Technical Service Bulletin

66 Rear spoiler is inoperative

66 21 79 2065220/1 December 7, 2021.

Model(s)	Year	VIN Range	Vehicle-Specific Equipment
Audi e-tron GT	2022	000001 - 005302	Not Applicable
Audi RS e-tron GT	2022	900001 - 902734	Not Applicable

Figure 2. Cutaway view of the motor brush to commutator area.

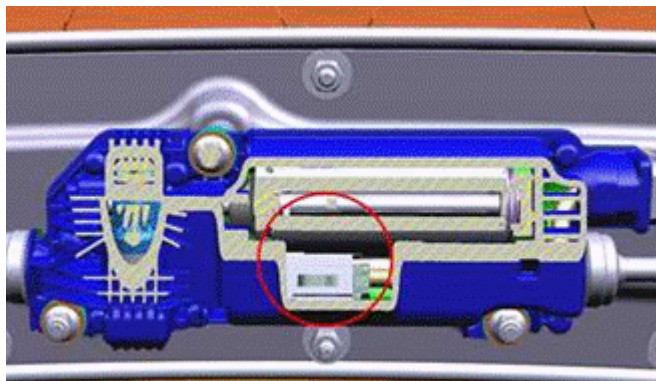
Due to insufficient pressure of the carbon brushes to the motor commutator in the spoiler drive motor a loss of contact may occur and cause intermittent or permanent loss of spoiler operation.

Figure 2 shows the spoiler drive motor area of brush to commutator contact.

The rear spoiler drive motor has been redesigned. An increase in brush to commutator pressure has been implemented in production.

Figure 3. Rear spoiler drive assembly.

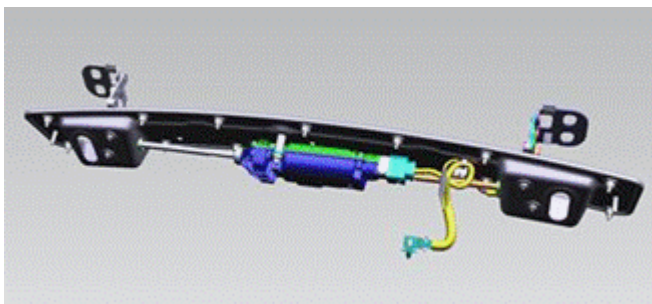
1. Should the vehicle exhibit the symptom profile described in this TSB, replace the rear spoiler drive unit. Figure 3 shows the rear spoiler drive assembly.
